GNRO-2002/00012

SUBJECT: Grand Gulf Nuclear Station, Unit 1
Docket No. 50-416
Supplement to Amendment Request Concerning
Control Rod Scram Time Testing Frequency

Response to Request for Additional Information Related to Scram Time Testing Intervals

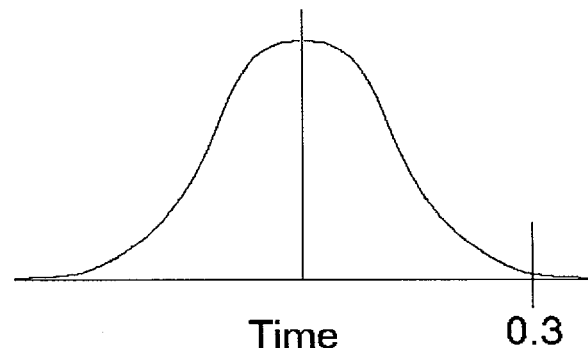
3. **Reference, Page 2, last paragraph, second sentence. "An evaluation of the historic average times and standard deviation in time..."**

- a) **How was the standard deviation calculated?**

The standard deviation of scram times was calculated by applying the standard deviation function in Excel to the measured scram times of the database population.
